SUBJECT: MIDLAND DIESEL GENERATOR BUILDING (DGB)

Subject: Visual Aids for April <sup>24</sup>~~25~~, 1984 Meeting w/ R. Vellmer, J. Keppeler and D. Essenhut (2:00 pm in D. Essenhut's office)

ADDITIONAL REQUIREMENTS FOR DGB EVALUATION

### Request for Additional Information Regarding Structural Adequacy of Midland Diesel Generator Building

FIGURE DGB-8B  
COMPARISON OF MEASURED SETTLEMENT VALUES WITH SETTLEMENT VALUES  
RESULTING FROM A FINITE ELEMENT ANALYSIS OF THE DIESEL GENERATOR BUILDING

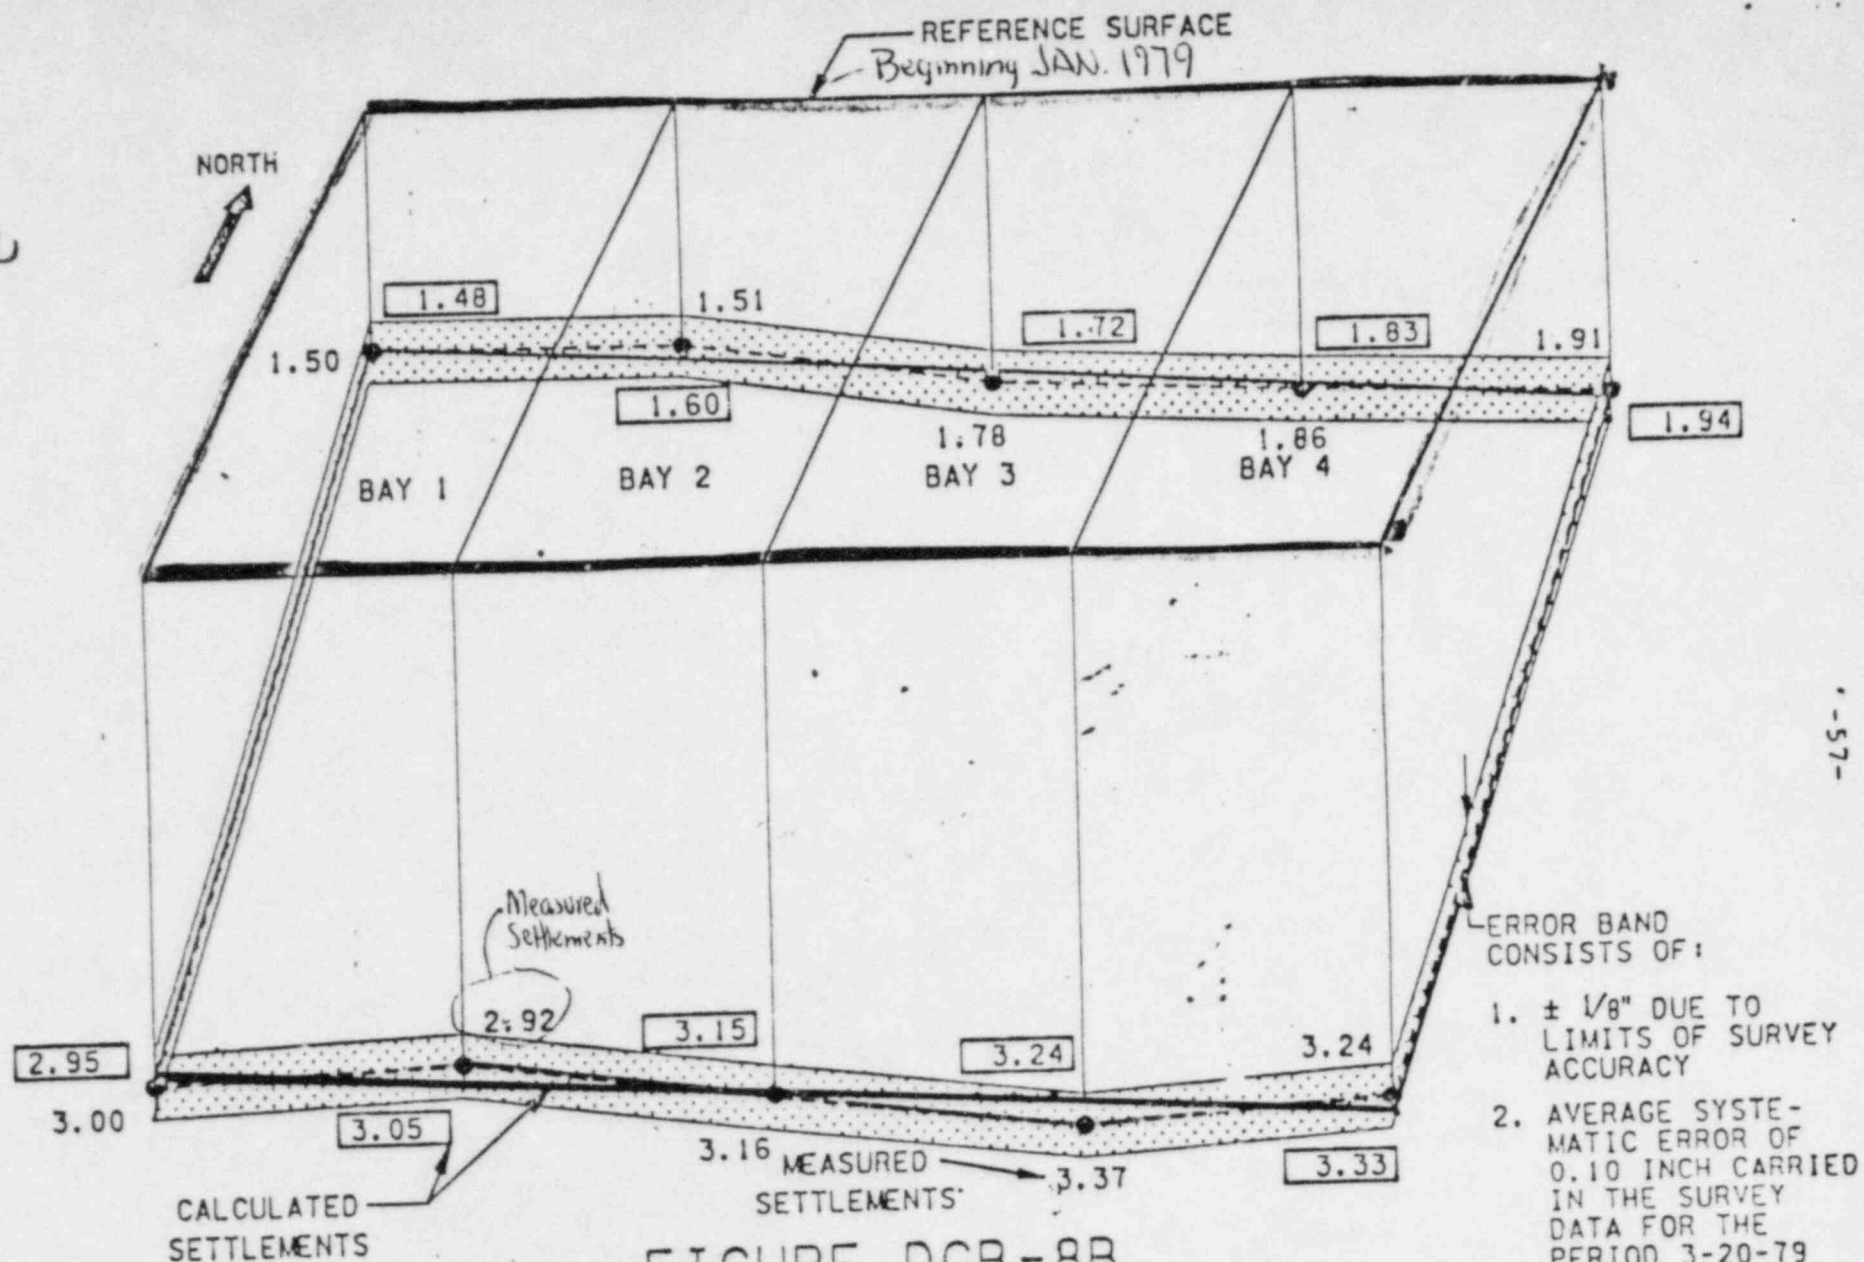
Line C on previous vugraph
